**Item No. 12.1.1**  
**Appeals Standing Committee**  
**March 6, 2025**

**SUBJECT:** Appeal Report – BLAST-2024-09274 1190 Barrington Street, Halifax

# BLASTING VIBRATION CONTROL PLAN

Halifax Regional Municipality (HRM) has retained WSP Canada Inc. on September 10, 2024 to provide a review of blasting near the Henry House Property in Halifax, Nova Scotia.

**Figure 3.3** Typical Blast Layout

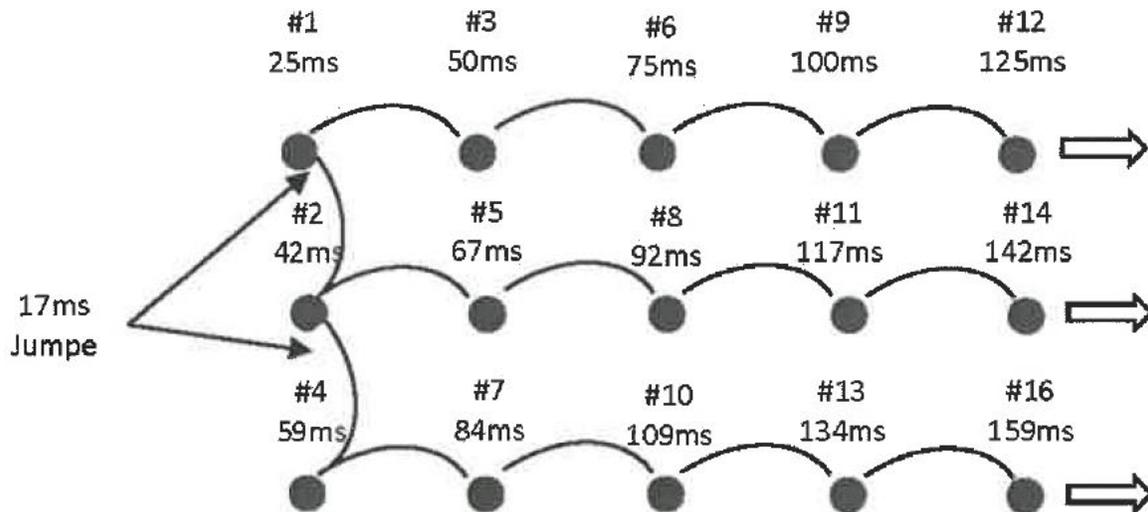
The objective of the blasting plan is to locate all sinking blasts away from the heritage site. Once the site is exposed such that future blasts will have at least one open face, blasthole loading should proceed using values in Table 3.3 for three to five blast events to monitor the response at Henry House. If monitoring verifies consistent response frequencies greater than 30 hertz, the scaled distance for design can be adjusted to the 20 to 40 range for the remainder of the project. In general, production blasts will progress away from the sinking blast radially.

**Figure 2: HRM Blasting Vibration Limits (By-Law B-600)**

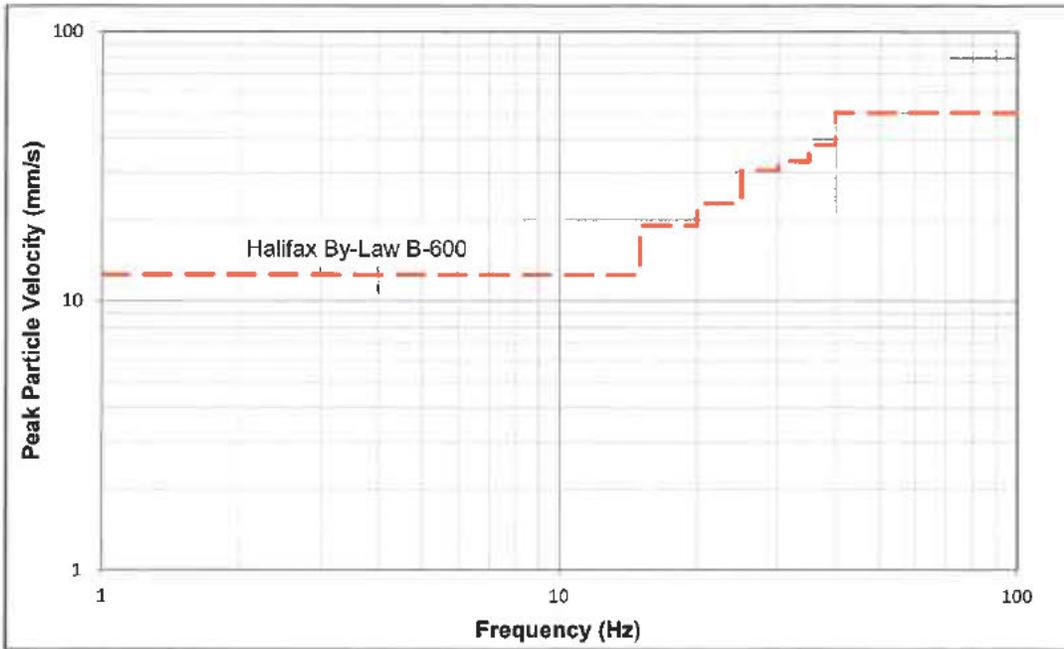
The blasting vibration limits shown above are intended to mitigate the potential impact on modern residential structures. Blasting near heritage structures is typically treated differently due to possible existence of weak components and or significant intrinsic value of some such structures for which special care is needed. Rainer (1982) stated that complications and uncertainties arise when attempting to assess the effect of vibrations on the historic buildings. They are as follows:

**Figure 3: Proposed Blasting Vibration Limits at Heritage Properties**

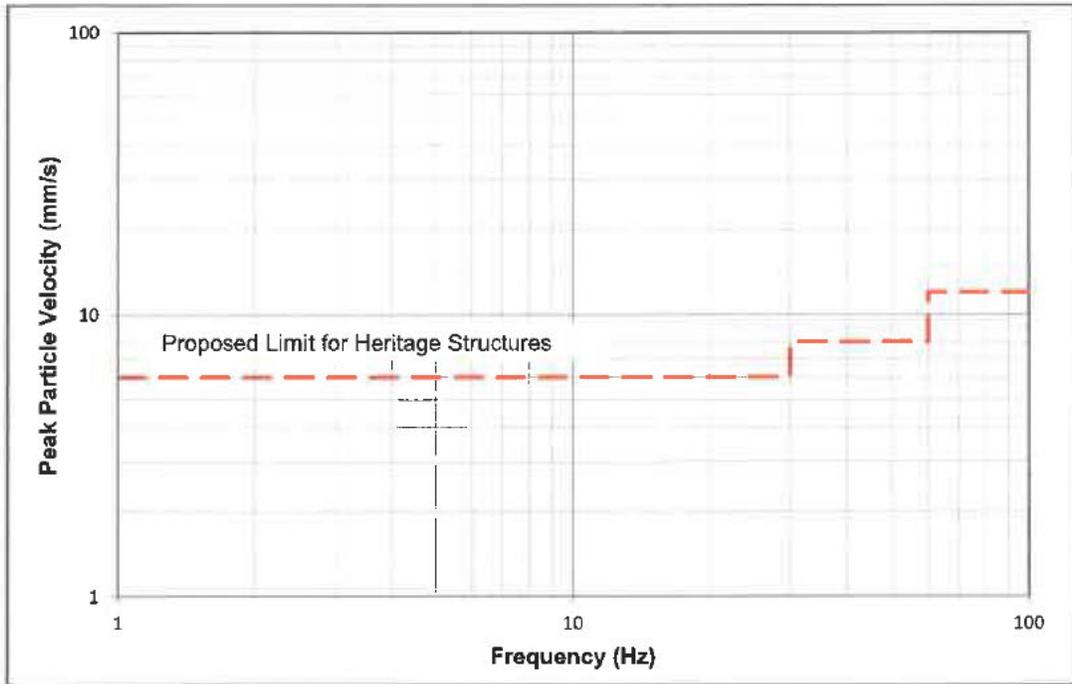
Based on the above discussion of published literature, the use of the Swiss standard SN640 312a is deemed appropriate for the proposed blasting at 1190 Barrington Street.

Based on the discussion of published literature presented above and as proposed by the Contractor, the use of the Swiss standard SN640 312a (noted as 'HRM By-law B-600 Limit for Heritage Structures) as it related to heritage structures is appropriate for the continuation of the blasting work on the 1190 Barrington Street project.
